**VILLAGE OF LOMBARD**  
**INTER-DEPARTMENTAL REVIEW GROUP REPORT**

**ZBA 08-15; 1300-1366 S. Finley Road:** The petitioner requests that the Village approve the following actions for the subject property located within the R5PD General Residential Planned Development District:

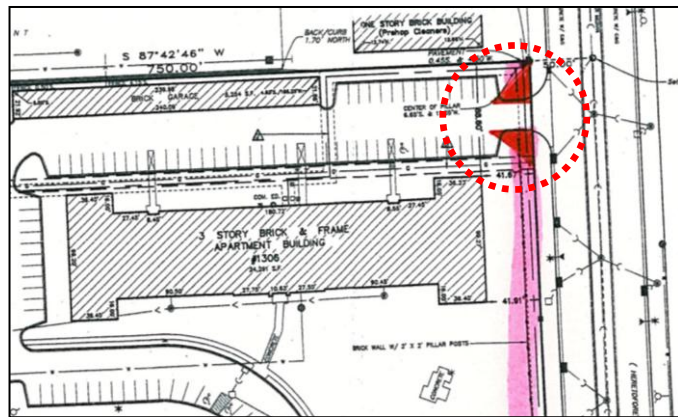
The petitioner is also seeking a variation to allow two (2) of the existing brick pillars at the northern driveway along Finley Road to be within the clear line of sight areas. Pursuant to the Zoning Ordinance, supporting members of a fence in the clear line of sight area shall not be greater than six inches (6") in width. The existing brick pillars are thirty inches (30") in width. The original planned development was silent with respect to fencing and no permit was issued for the wall as permits were not required until 2000.

The above plan shows the location of these pillars within clear line of sight triangles (in red). Currently, the pillar on the southern side of the driveway is of only minor concern regarding visibility as the driveway is right turn in and right turn out only. The pillar on the northern side of the driveway could block some visibility to and from Finley Road. However, the petitioner's proposal will actually increase visibility in the clear line of sight area as the fence will be of open construction.

5. The variation to allow the brick pillars to remain in the clear line of sight area shall be applied only to the two pillars directly adjacent to the northern driveway along Finley Road.

6. In the event that either of the two brick pillars directly adjacent to the northern driveway along Finley Road are destroyed or deconstructed to fifty percent (50%) of their value, they shall neither be reconstructed nor shall any supporting member of the fence greater than six inches (6") in width be constructed within the clear line of sight area.
